Reference No: HDC (161)-MKS/IU/2022/173

ADDENDUM 1

Project Name: Development and Operation of Warehouse in Thilafushi

Proposal Reference Number: HDC (161)-BSI/IU/2022/122

DRAWING: LOCATION MAP

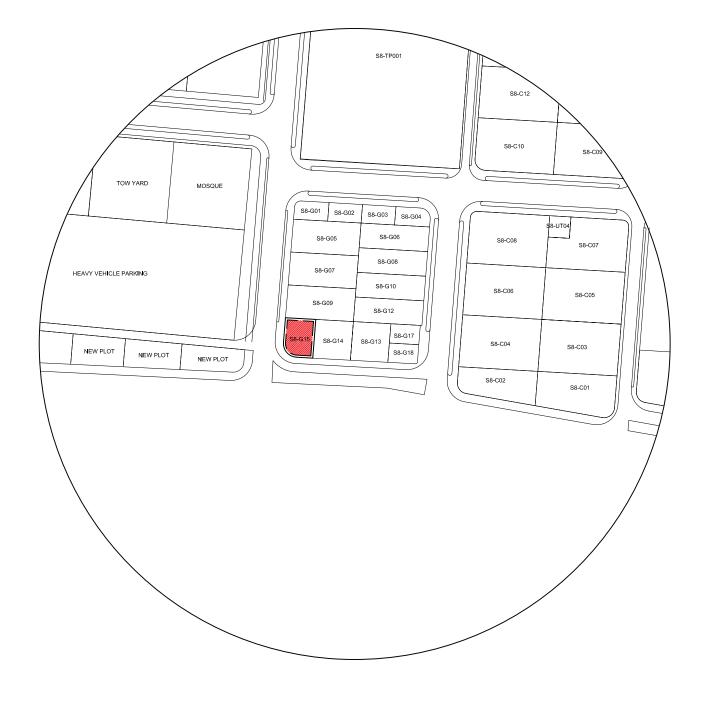
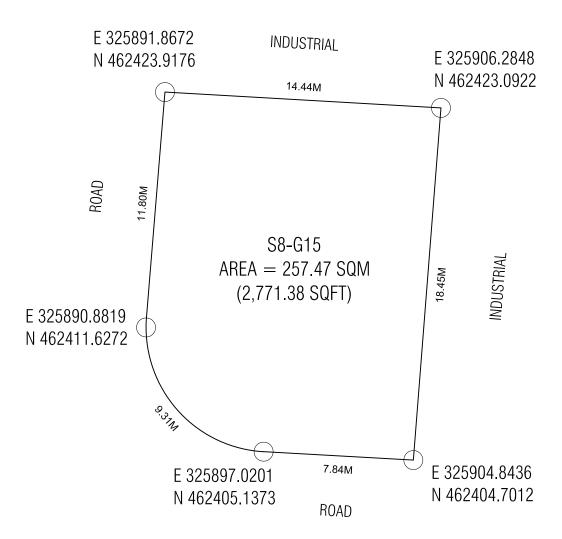
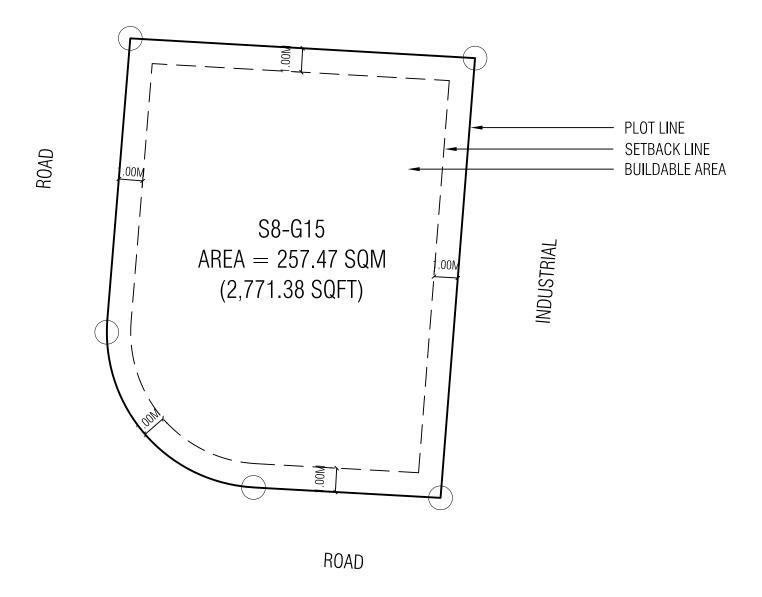
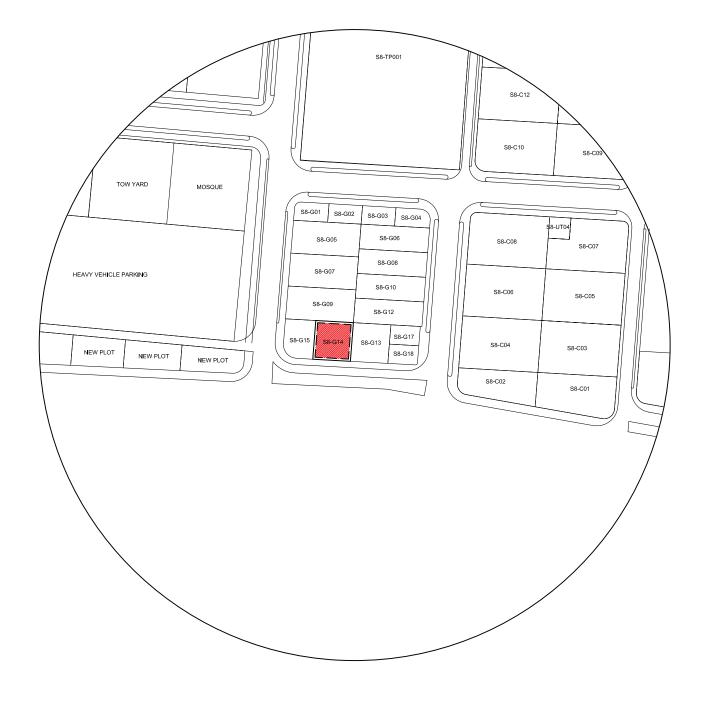
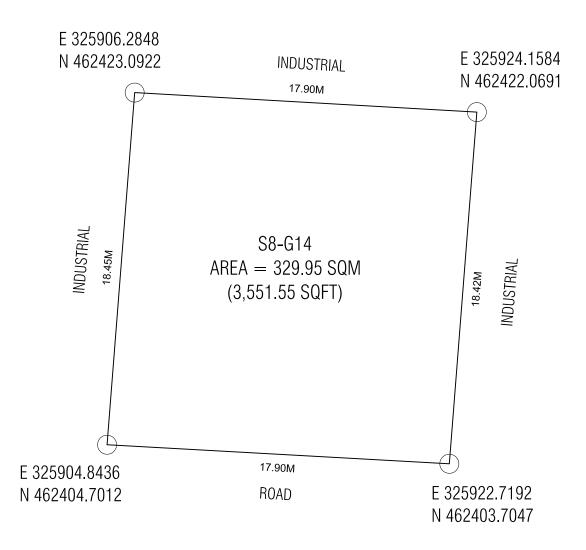
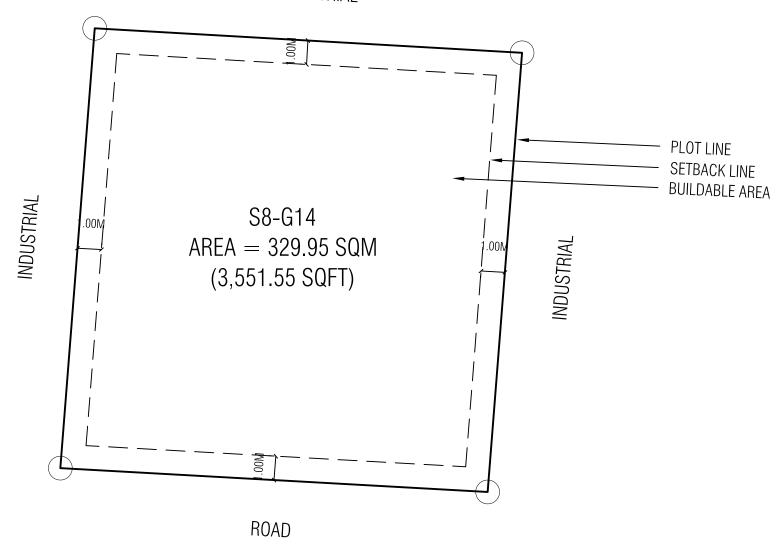
Section III. Lessor's	Change:		
Requirement, 4. Plot Details	Plot Number	Usage	Plot Area (sqft)
	S8-G10	Warehouse	4,126.21
	S8-G12		4,125.98
	S8-G14		3,551.55
	S8-G15		2,771.38
SSection VI. Contract Change:			
Clause 3. Land Plot	Plot Number		Plot Area (sqft)
	S8-G10		4,126.21
	S8-G12		4,125.98
	S8-G14		3,551.55
	S8-G15	2,771.38	
Section VII. Drawings and Guidelines Clause 1. Drawings	Change: 1. Drawings (Refer to Next Page)
